Docket Number:	12-AFC-02
Project Title:	Huntington Beach Energy Project
TN #:	202666
Document Title:	SCAQMD Response Letter to Public Comment
Description:	N/A
Filer:	Andrew Lee
Organization:	South Coast Air Quality Management District
Submitter Role:	Public Agency
Submission Date:	7/3/2014 8:12:10 AM
Docketed Date:	7/3/2014

Subject: Huntington Beach Energy Project (HBEP)
 Preliminary Determination of Compliance, Response to Comments

Figure 1. Annual Arithmetic Mean PM10 Particulate Matter ($\mu\text{g}/\text{m}^3$) in 2011.

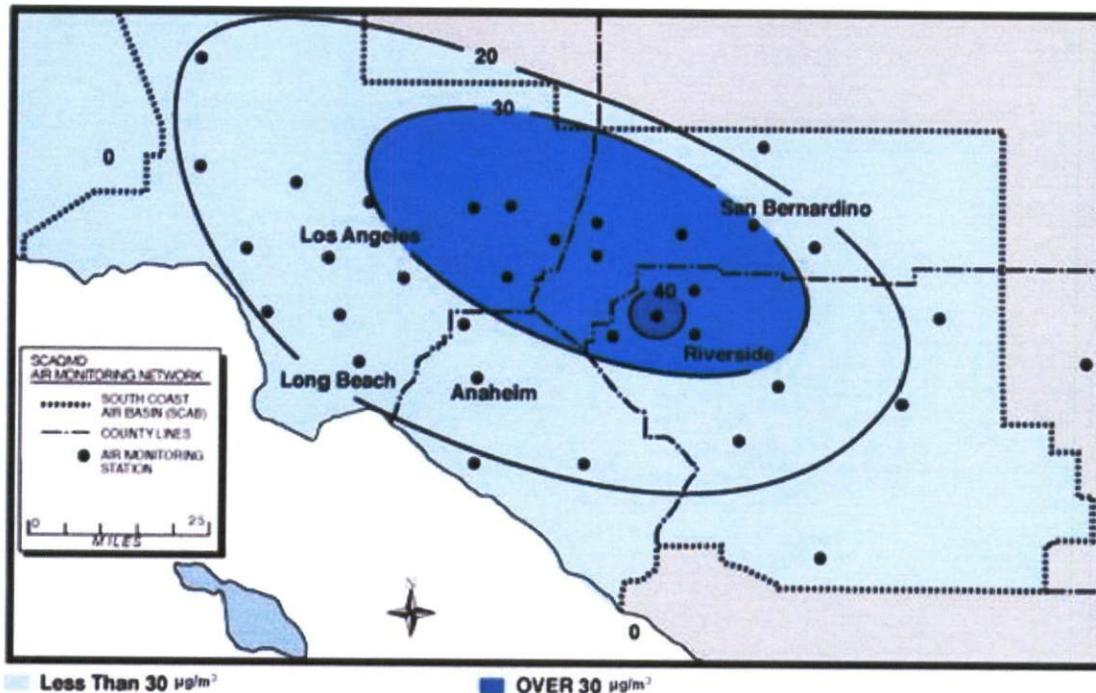
Your comment centers around the issue of the actual PM10 emissions from the existing plant as compared to the new plant's potential to emit (PTE), and the health effects of the particulate emissions.

Furthermore, the PM10 and PM2.5 air quality of coastal Orange County (i.e., area of the proposed project) is among the cleanest regions in the four-county jurisdictional area of the SCAQMD; see Figures 1 through 3, which are taken from the 2012 Air Quality Management Plan (<http://www.aqmd.gov/aqmp/2012aqmp/index.htm>). As shown in Figure 1, the annual PM10 air quality is well below the old annual National Ambient Air Quality Standard (NAAQS) of 50 mg/m^3 (The annual PM10 NAAQS was revoked in 2006). The whole four-county jurisdictional area (including coastal Orange County) currently meets the 24-hour PM10 NAAQS of 150 mg/m^3 . As shown in Figures 2 and 3, the PM2.5 air quality along coastal Orange County is below the 24-hour and annual NAAQS of 35 mg/m^3 and 12 mg/m^3 , respectively. It is anticipated that the Huntington Beach area will continue to have some of the cleanest air quality levels amongst the four-county jurisdictional area of the SCAQMD even with the development of the Huntington Beach Energy Project.

Figure 4. Model-estimated inhalation cancer risk for MATES III (2005 time period).

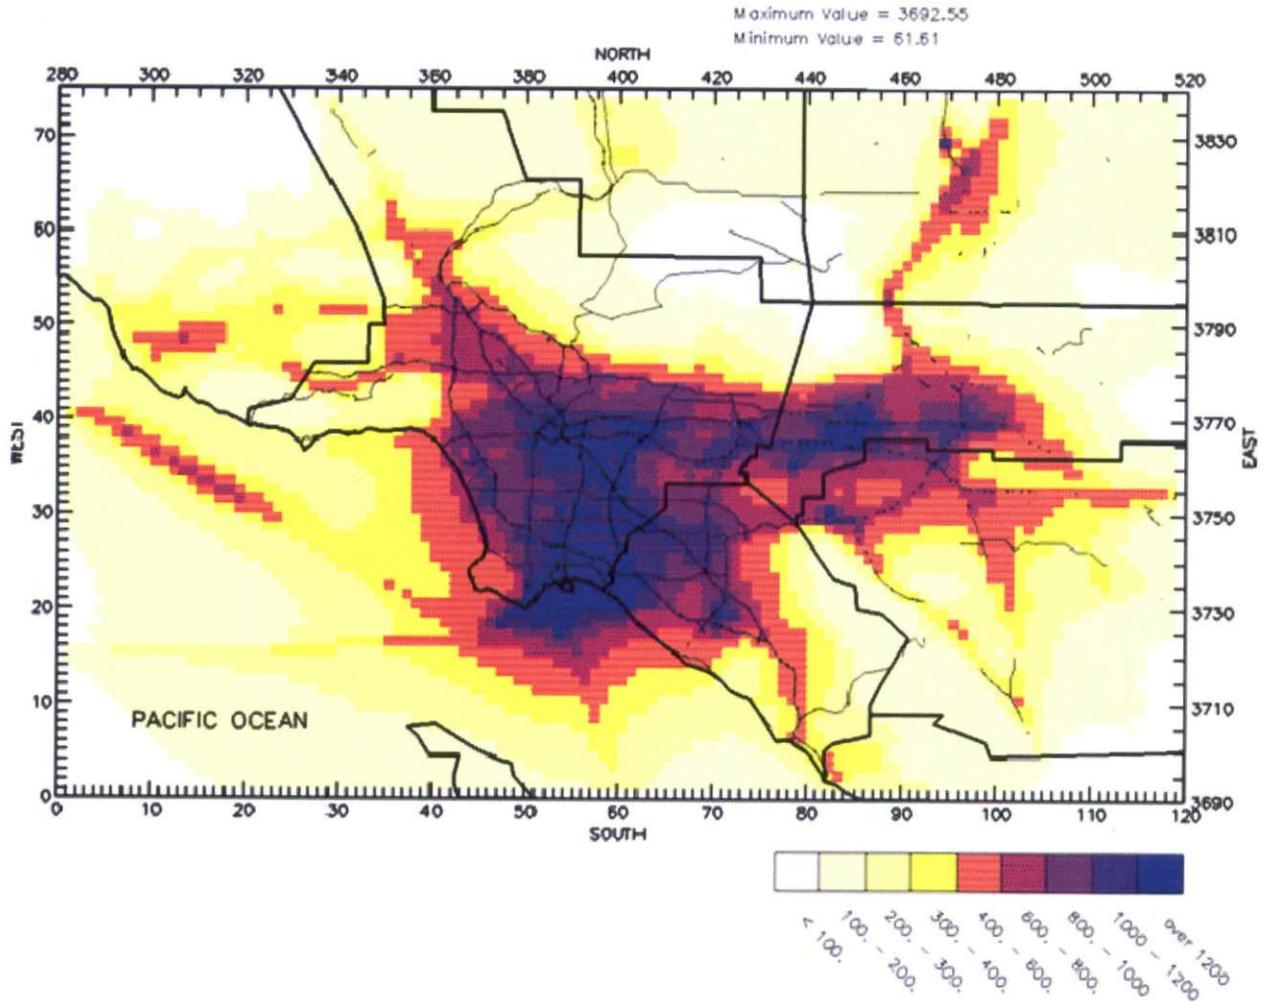
Your comment pertains to the health effects of the project on long-term residents living in the area.

It should be noted that coastal Orange County, the site of the project, has some of the lowest inhalation cancer risks in the jurisdictional area of the SCAQMD as shown in Figure 4, which was taken from the Multiple Air Toxics Exposure Study (MATES) III report (<http://www.aqmd.gov/prdas/matesIII/matesIII.html>). MATES IV reports are currently under development and should be available in the summer of 2014. Coastal Orange County will continue to have some of the lowest inhalation cancer risks in SCAQMD's jurisdictional area.
